AGENDA

Town Council Agenda Meeting

b. PD-11-22: Knollwood Tract Phase 2 MFR PDP

Subject: PD-11-22: A Planned Development District - Preliminary Development Plan for Knollwood Multi-Family; Applicant: Hawthorne Residential Partners, Philip Payonk; Bob Koontz of KoontzJones Design PLLC, Authorized Agent; Owners: Knollwood Partners, LLC, Mid-Pines Development Group, LLC, and Kaveri Investment Management Co, LLC

Figure 5: Connector (“Spine”) Road Cross-Section from CDP

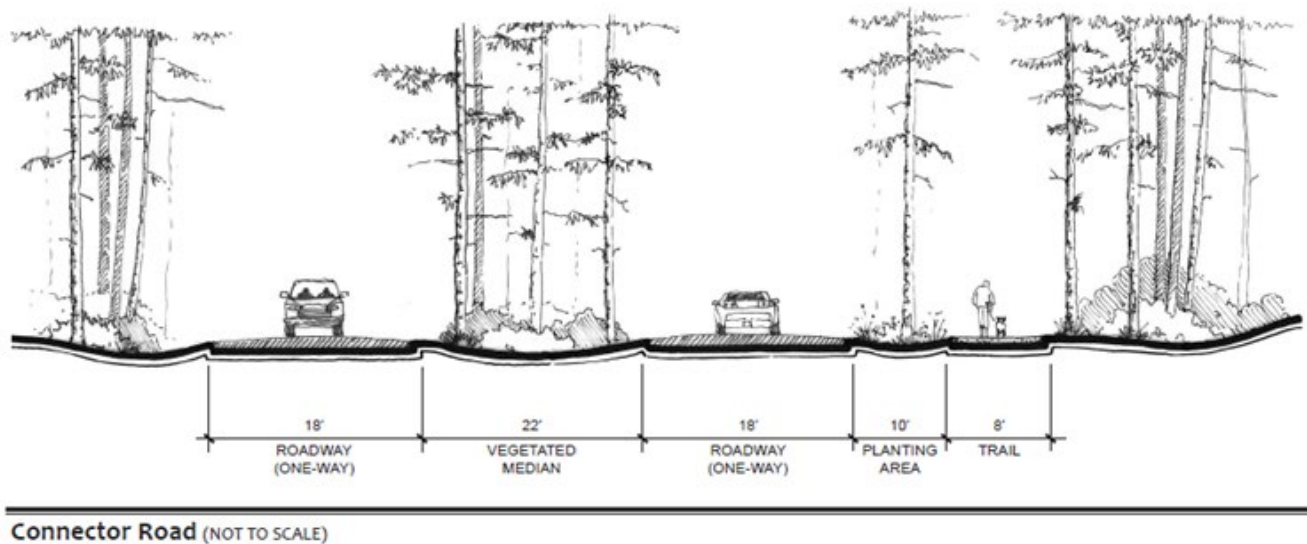
- a. The CDP presents a road which includes road side ditches and median drainage. The cross section presented also shows significant landscaping and trees within the ditches and drainage ways.

This cross section would provide an aesthetically pleasing road and driving experience, though it is unclear to me how this aesthetic is proposed to be met based on the information in the PDP. If I assume that the applicant will provide a street landscaping plan as shown in the above figure it will present a significant maintenance burden as all of the drainage ways would be filled with vegetation meaning that Public Works staff could not use standard practices when repairing or regrading the ditches over the life of the road. The vegetation could also interfere with proper drainage as it creates potential blockages in the drainage ways. The PDP does provide a similar cross section (but again it is unclear as to the level of planting being

Figure 6: Connector (“Spine”) Road Cross-Section from PDP

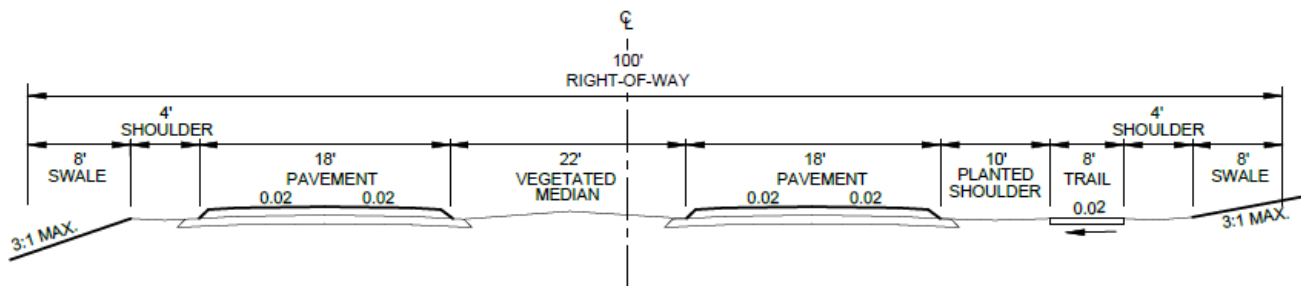
proposed) that presents the same maintenance challenges as the CDP cross section.

Figure 7: Buffer Treatment for US-1 Proposed in the CDP

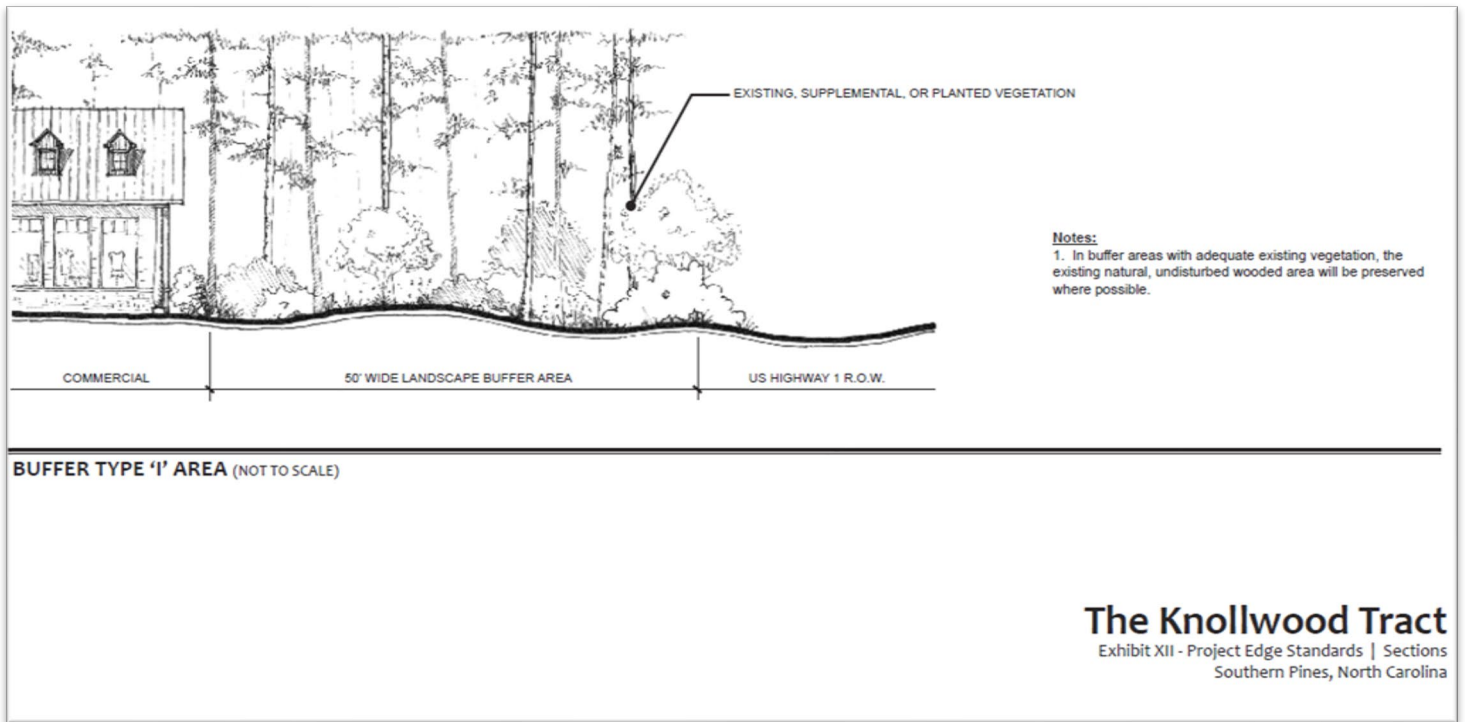
“Existing vegetation may be utilized and enhanced with landscaping and hardscape features. Utilities and project monument signage may be installed within Project Edge at drive entries. Primary signage may be installed at three drive entries as demonstrated on the Land Use Plan and Conceptual Master Plan. Community greenway trail may be installed in Project Edge.”

Figure 9: Enlargement of Development Layout Proposal from CDP Exhibit X – Conceptual Development Plan (It should be noted that the conceptual layout has changed dramatically, in part as a result of updated data on wetlands locations)

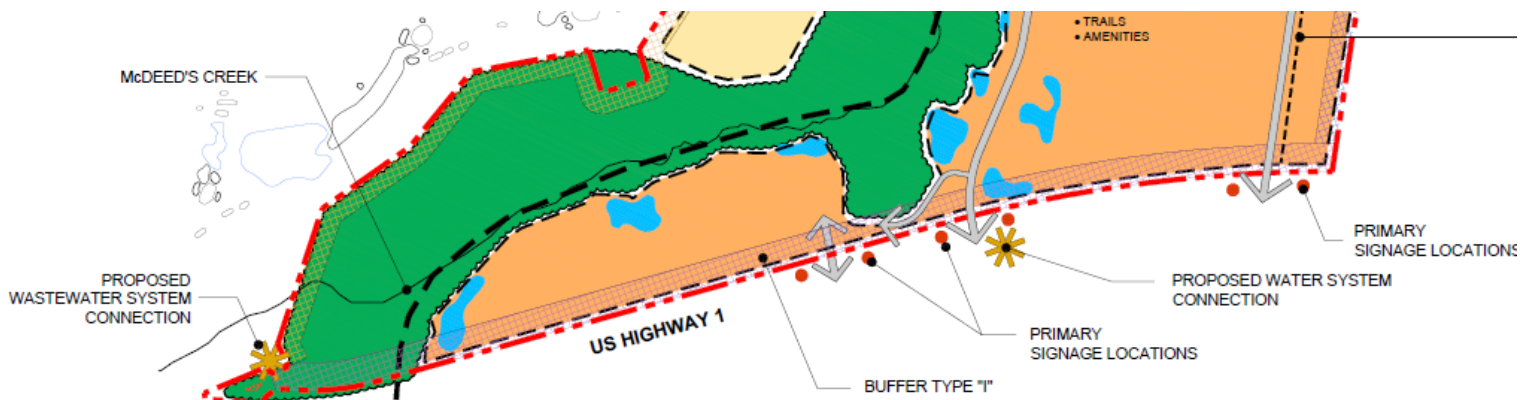
- d. *Street standards included in the CDP include a seventy-four foot wide cross-section for the “Connector Road” that is meant to access this project.*
